TABLE 9-1

CALVERT CLIFFS 1 CYCLE 7
TECHNICAL SPECIFICATION CHANGES

TABLE 9-2
EXPLANATIONS FOR CYCLE 7 TECH. SPEC. CHANGES

Figure 3.2-3b

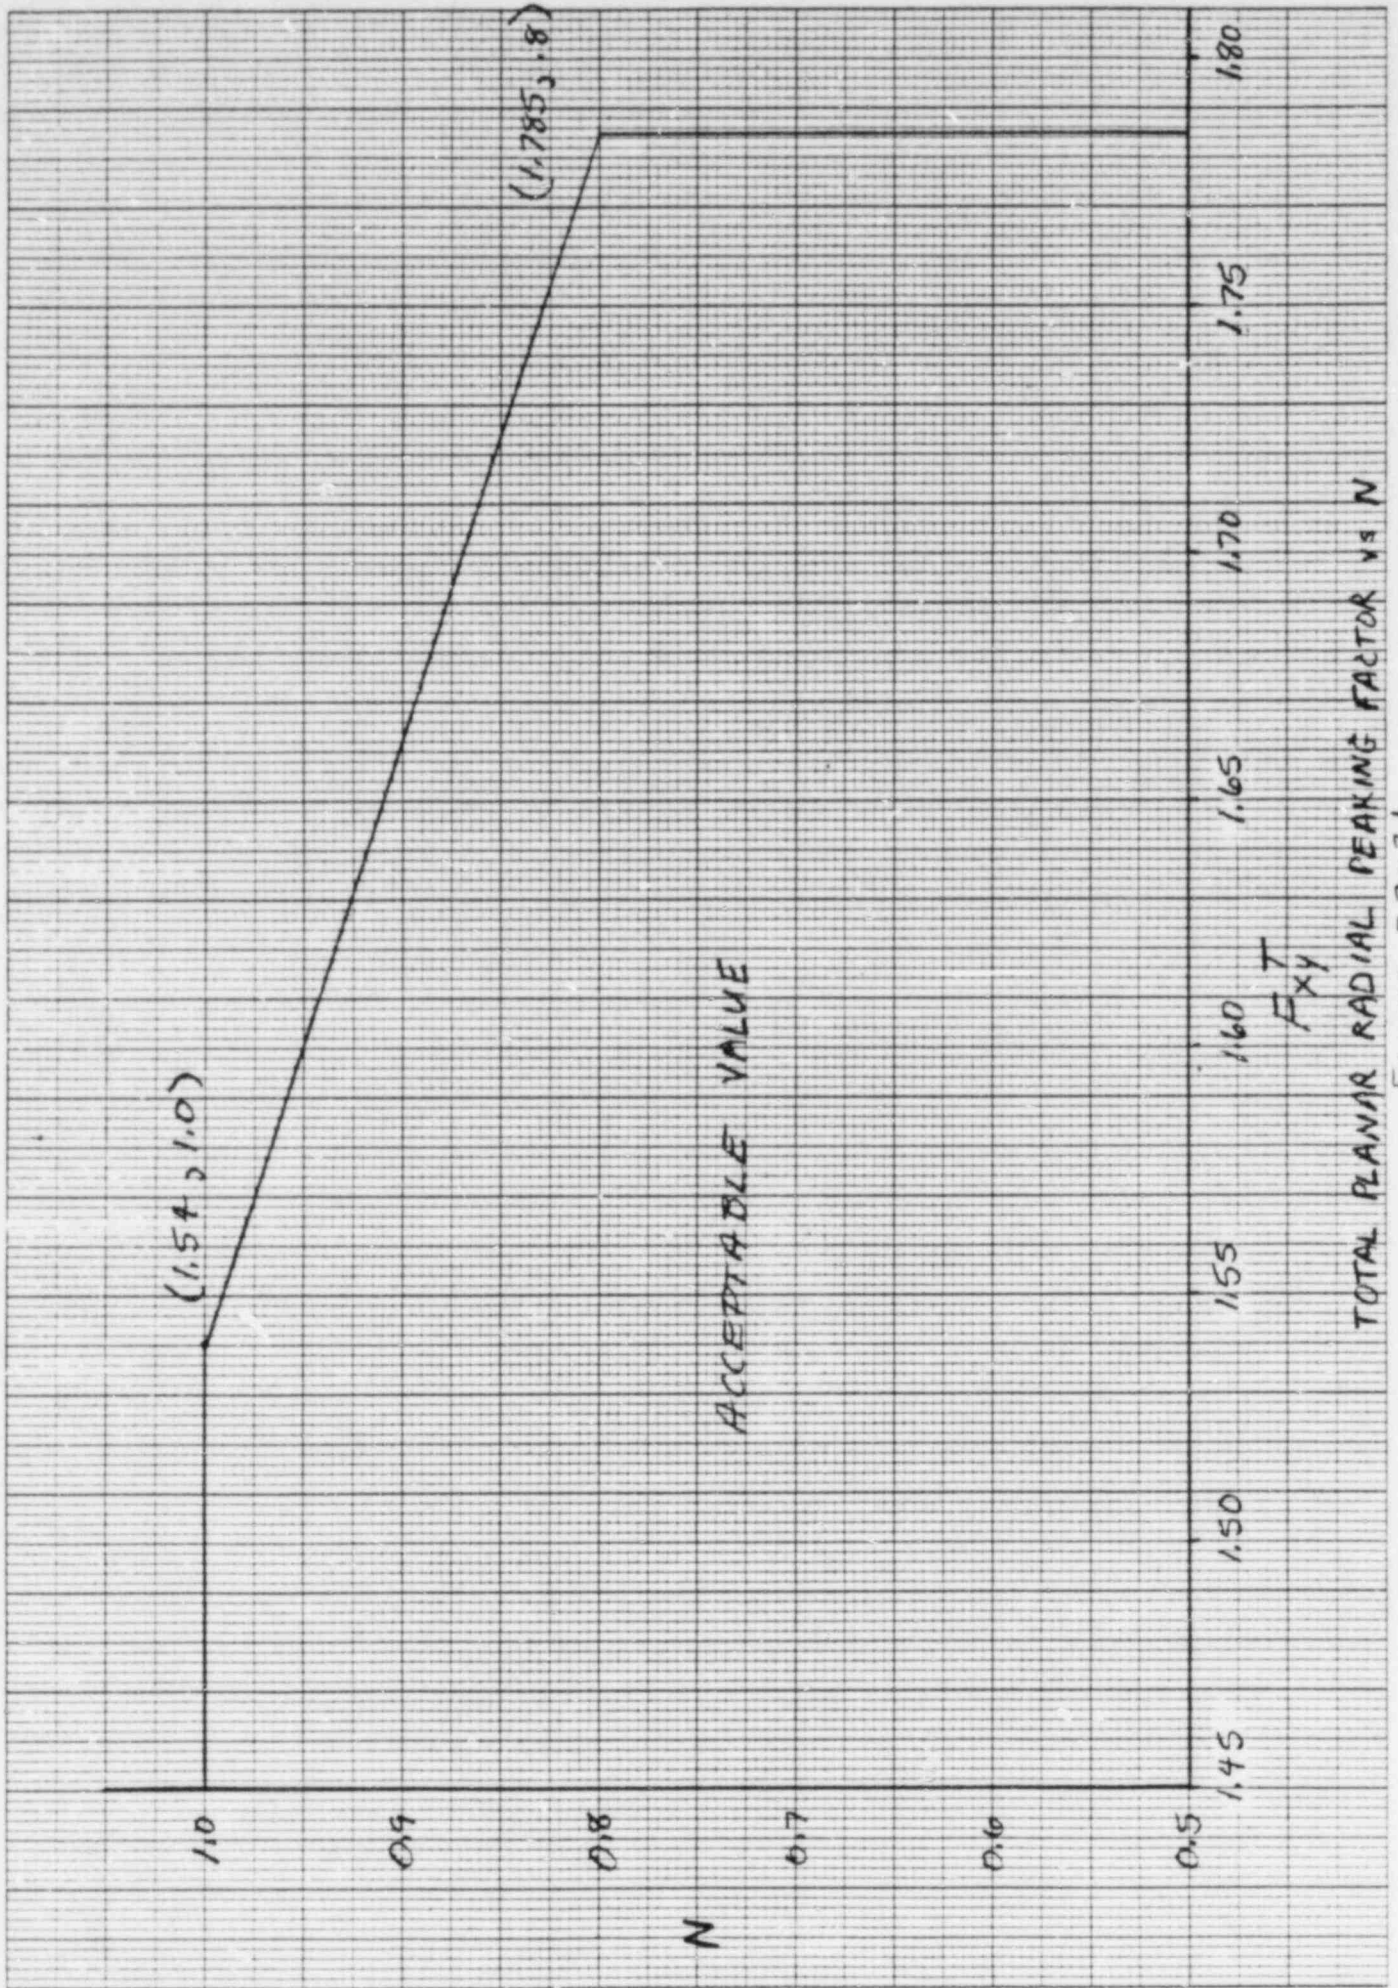
9	Figure 3.2-3b page 3/4 2-4a	Replace Figure 3.2-3b with enclosed Figure 3.2-3b.
10	3.2.2.1 page 3/4 2-6	Change calculated value of F_{xy}^T from 1.65 to 1.70.
11	Figure 3.2-3a page 3/4 2-7a	Replace Figure 3.2-3a with enclosed new Figure 3.2-3a
12	3.2.3 page 3/4 2-9	Change Figure 3.2-3a to Figure 3.2-3c.
13	Figure 3.2-3c page 3/4 2-10a (new)	Insert enclosed new Figure 3.2-3c after page 3/4 2-10.
14	Table 3.2-1 page 3/4 2-14	Change minimum pressurizer pressure from 2225 psia to 2200 psia.

8	4.1.1.4.2	The surveillance requirements on MTC are being modified to allow the use of MTC determinations made during power ascension startup measurements for the purpose of satisfying surveillance requirements. This change is consistent with the objective of assuring that the most positive MTC at power conditions, which occurs at the highest boron concentration, meets Tech. Spec. 3.1.1.4.b.
9	Figure 3.2-3b	Figure 3.2-3b is being revised due to the separation of the allowable F_{xy}^T and F_{xy}^T curves into separate figures (see Change Nos. 11, 12 and 13).

FIGURE 3.2-3a

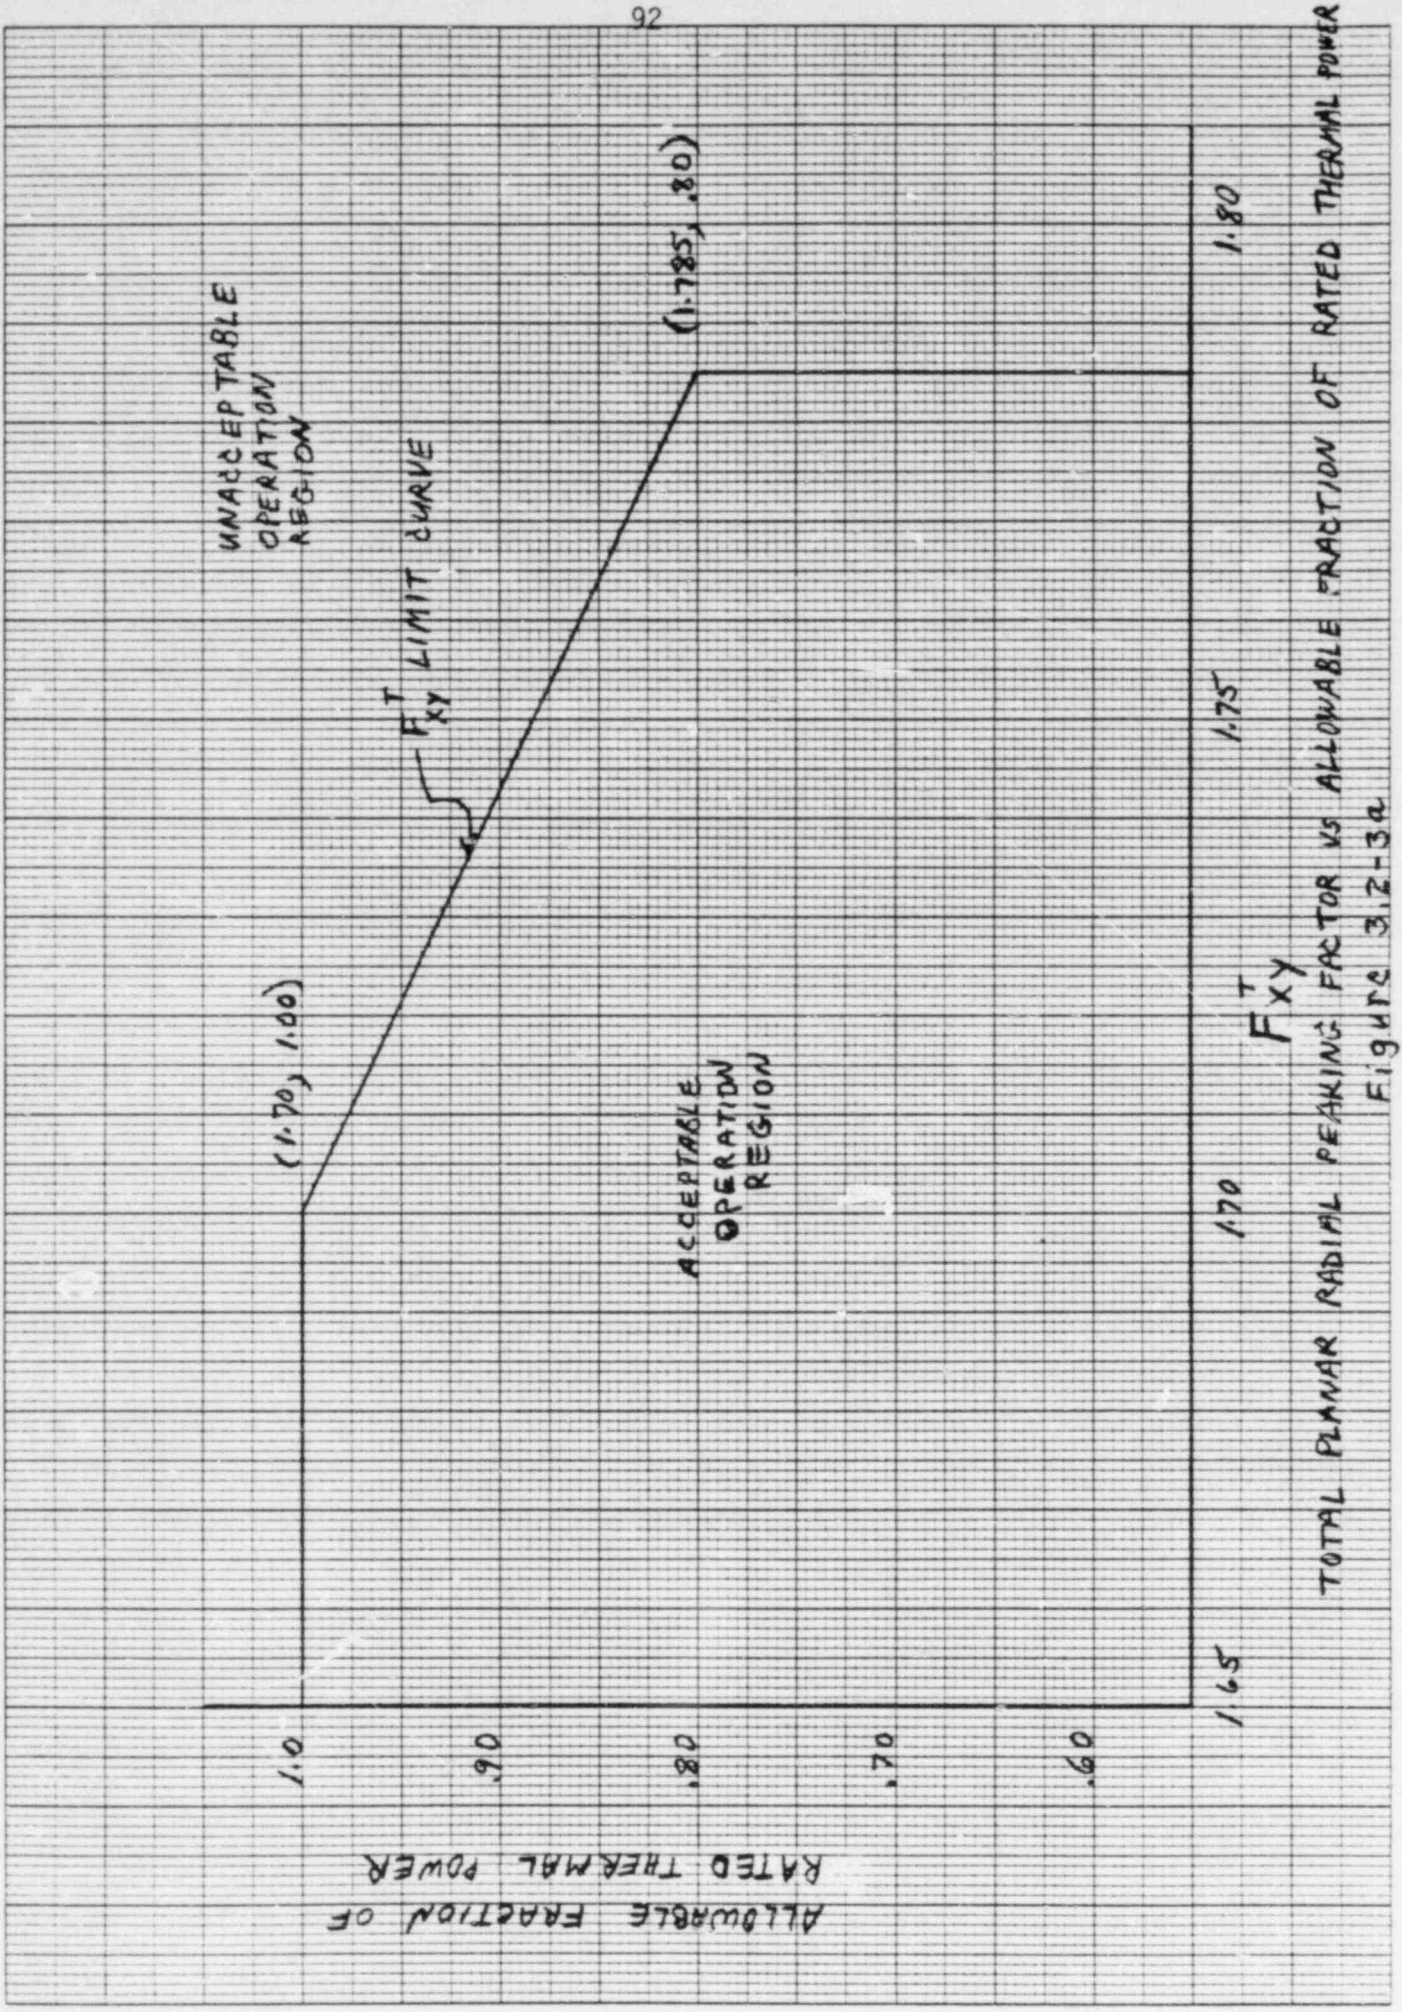
<u>Changes</u>	<u>Tech. Spec. #</u>	<u>Explanation</u>
10	3.2.2.1	The planar radial peaking factor, F_{xy}^T , is being raised for Cycle 7 to increase operating margins and flexibility.
11	Figure 3.2-3a	The planar radial peaking factor, F_{xy}^T , is being raised for Cycle 7 to increase operating margins and flexibility and the F_{xy}^T curve is being separated from the F_r^T curve to accommodate different F_{xy}^T and F_r^T values.
12	3.2.3	Figure 3.2-3c is being added to facilitate the separation of the F_{xy}^T and F_r^T curves to accommodate different F_{xy}^T and F_r^T values.
13	Figure 3.2-3c	See Change No. 12.
14	Table 3.2-1	The minimum steady state pressurizer pressure has been lowered to increase operating flexibility.
15	Table 3.3-1	See Change No. 2.
16	Table 3.3-3	The description of the Engineered Safety Feature Actuation System Instrumentation for Auxiliary Feedwater is being revised and augmented to reflect the implementation of the Safety Grade Auxiliary Feedwater Actuation System.
